Product Change Notification - SYST-10GTDD251

ERRATA - dsPIC33EVXXXGM00X/10X Family Silicon Errata and Data Sheet Clarification

Description of Change: 1) Adds silicon revision AE. 2) Removes all Data Sheet Clarifications as they were addressed in the new revision of the data sheet.

dsPIC33EVXXXGM00X/10X Family Silicon Errata and Data Sheet Clarification

FIGURE 1:

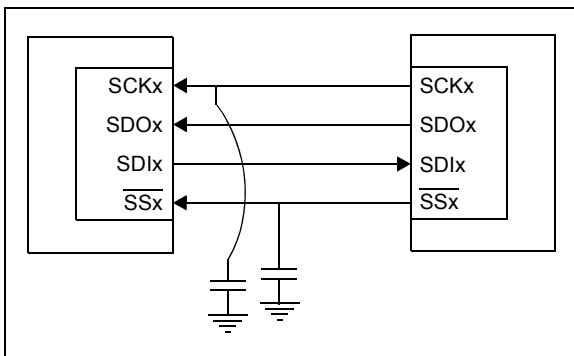
When the SPIx module is configured in SPIx Slave mode (MSTEN bit (SPIxCON1[5]) = 0), the frame slave (FRMEN bit (SPIxCON2[15]) = 1) and the SPIFSD bit (SPIxCON2[14] = 1), in Standard Buffer mode with the Clock Polarity Select bit, CKP = 0, the data are not transmitted in both 8-bit and 16-bit mode, but the data are being received correctly.

Adding a capacitance on the signal, as shown in Figure 1, will help the data to be received properly.

FIGURE 2: TIMING DIAGRAMS FOR CENTER-ALIGNED AND EDGE-ALIGNED MODES

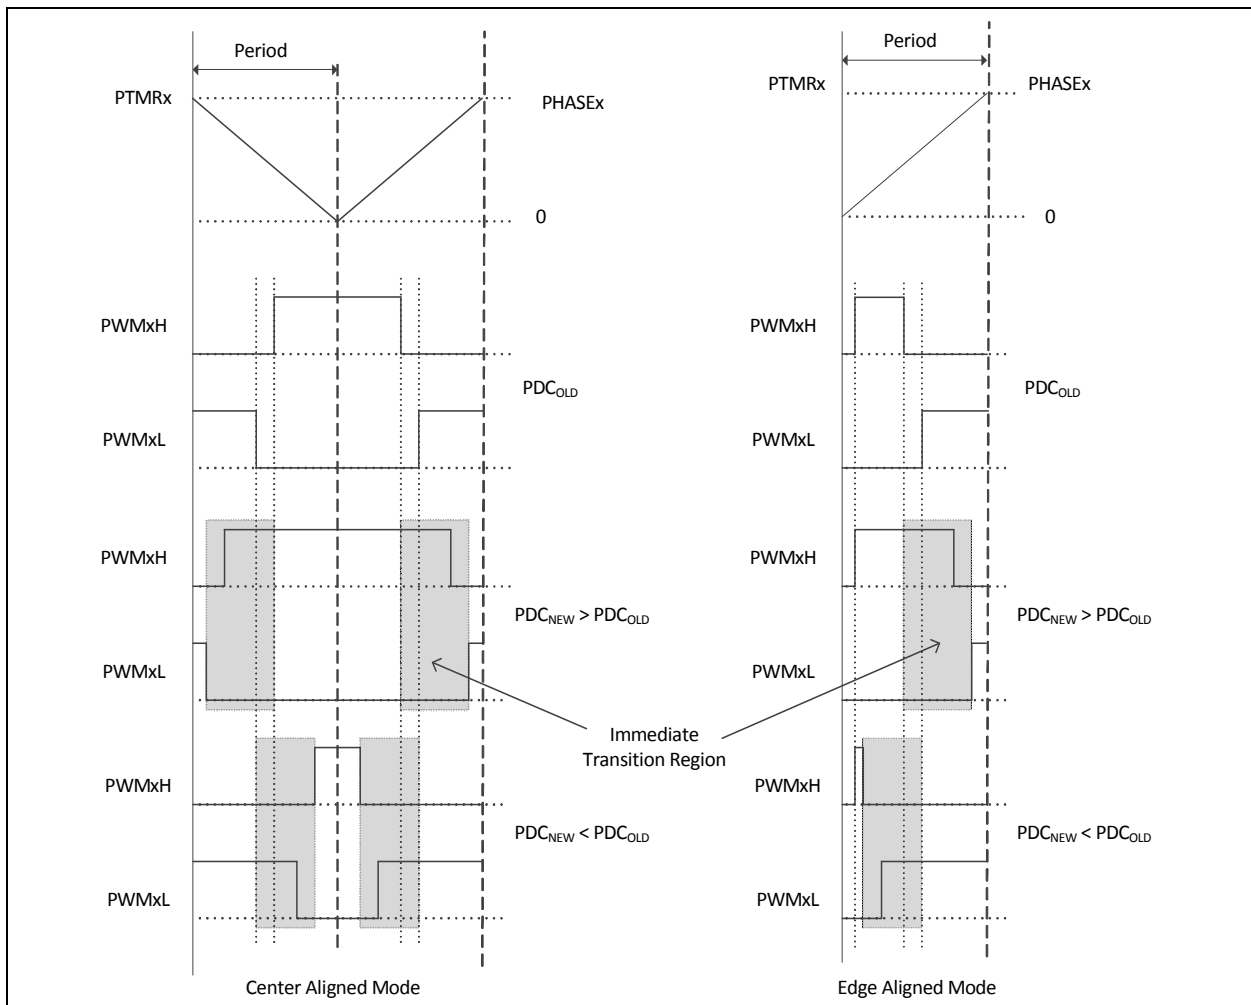
The PWM generator may not assert dead time on the edges of transitions. This has been observed when all of the following conditions are present:

In [Figure 2](#), if the duty cycle write occurred in the shaded box, then PWMxH and PWMxL will make an immediate transition without dead time.

However, in most applications, the duty cycle update timing can be controlled using the TRIGx trigger or Special Event Trigger, such that the above mentioned conditions are avoided altogether.

FIGURE 3: ILLUSTRATION OF 1 T_{osc} GLITCH WHEN PWM OVERRIDE IS TURNED OFF

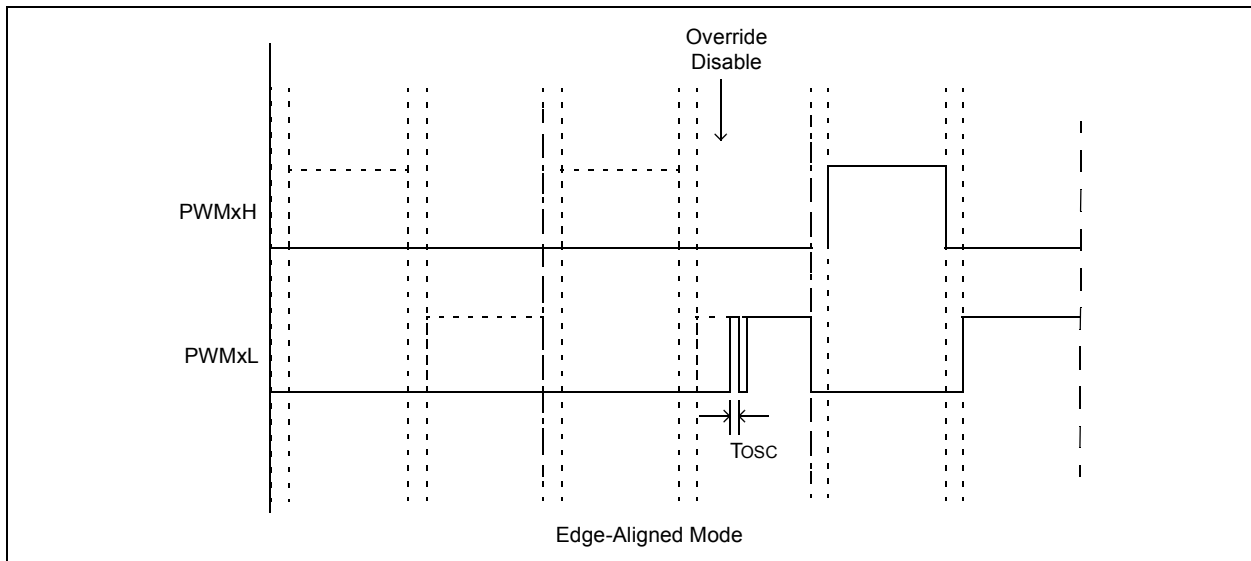
In Complementary mode after the PWM module is enabled (PTEN = 1), if the PWM override is turned off, a one T_{osc} glitch will be present on the rising edge of either the PWMxH or PWMxL pins, whichever occurs first, as shown in Figure 3.

The glitch will be present on PWMxH/PWMxL every time the override state is changed from override enabled to override disabled. The width of this glitch is equal to one T_{osc} when PCLKDIV[2:0] (PTCON2[2:0]) = 000. Increasing the PWMx input clock prescaler setting will increase the width of the glitch accordingly.

FIGURE 4:

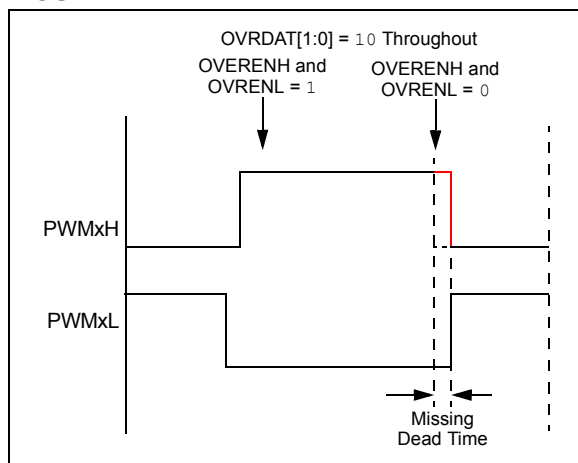
In Complementary Output mode, the expected dead time between transitions of the PWMxH and PWMxL outputs may not be asserted when the following occurs:

- Output override synchronization is configured to occur on the CPU clock boundary (IOCONx[0] = 0);
- Both PWMxH and PWMxL overrides are enabled prior to the event (OVRENH and OVRENL are both '1'), and
- Both overrides are disabled (OVRENH and OVRENL are both '0') at the instant the dead time should be asserted (Figure 4). This has been observed in both Center-Aligned and Edge-Aligned modes.

FIGURE 5:

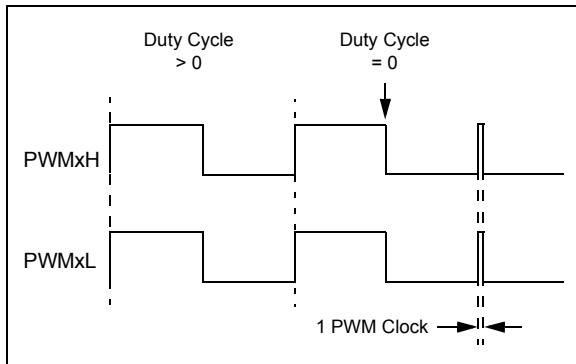
In the Redundant Output mode (IOCONx[11:10] = 10) and Push-Pull Output mode (IOCONx[11:10] = 01) with Immediate Update disabled (PWMCONx[0] = 0), when the Duty Cycle register is updated from a non-zero value to zero, a glitch pulse of a width equal to one PWM clock will appear at the next PWM period boundary, as shown in Figure 5, for the Redundant Output mode. Here, the Duty Cycle register refers to the PDCx register if PWMCONx[8] = 0 or the MDC register if PWMCONx[8] = 1.

FIGURE 6:

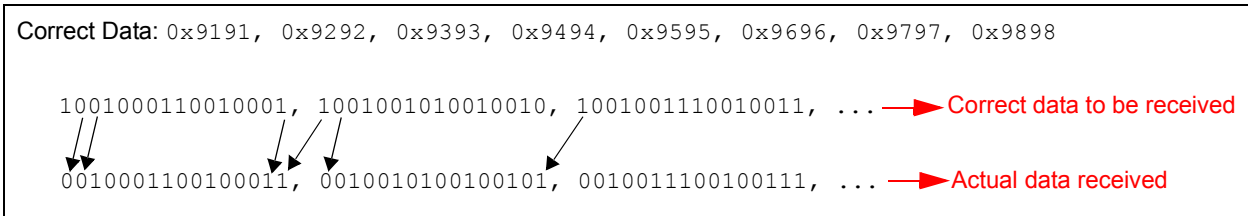
1. When the SPI is configured as master (MSTEN = 1), frame sync pulse input (SPIFSD = 1), enhanced buffer (SPIBEN = 1), CKP = 1, SMP = 1, FRMPOL = 1, FRMDLY = 1.
2. When the SPI is configured as master (MSTEN = 1), frame sync pulse input (SPIFSD = 1), enhanced buffer (SPIBEN = 1), CKP = 1, SMP = 1, FRMPOL = 0, FRMDLY = 0.

For example, the correct data that should be received are 0x9191, 0x9292, 0x9393, 0x9494, 0x9595, 0x9696, 0x9797, 0x9898, but the actual data received are 0x2323, 0x2525, 0x2727, 0x2929, 0x2B2B, 0x2D2D, 0x2F2F, 0x3130 (Figure 6).

FIGURE 7: SIMPLIFIED BEHAVIOR

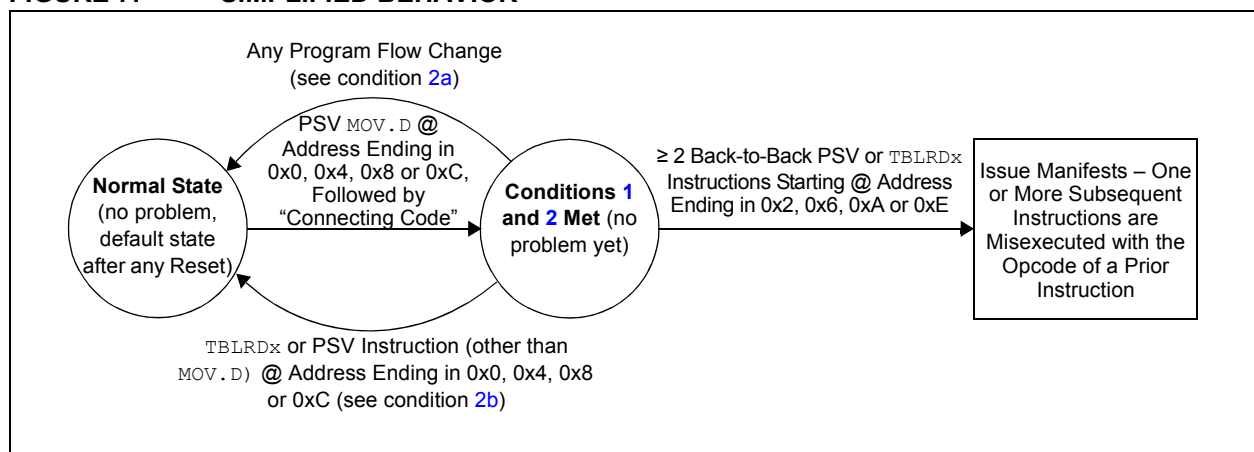
| 3. | ≥ 2 back-to-back PSV or <code>TBLRDx</code> instructions are executed (following the code of condition 2), where the first of the back-to-back instructions is located at an address ending in 0x2, 0x6, 0xA or 0xE. |

[Figure 7](#) provides an example of the effective behavior.

1. All instances of PSV `MOV.D` can be replaced with two PSV `MOV` instructions instead. Non-PSV `MOV.D` instructions acting on RAM/SFRs do not need to be modified; or
2. If not already present, a program flow change instruction (such as `BRA $+2`) can be inserted above back-to-back data Flash read sequences; or
3. Back-to-back data Flash read instruction sequences can be broken up by inserting a non-Flash read instruction (such as a `NOP`), in between the Flash read instructions; or
4. The alignment of the code can be shifted to avoid the required opcode location addresses.
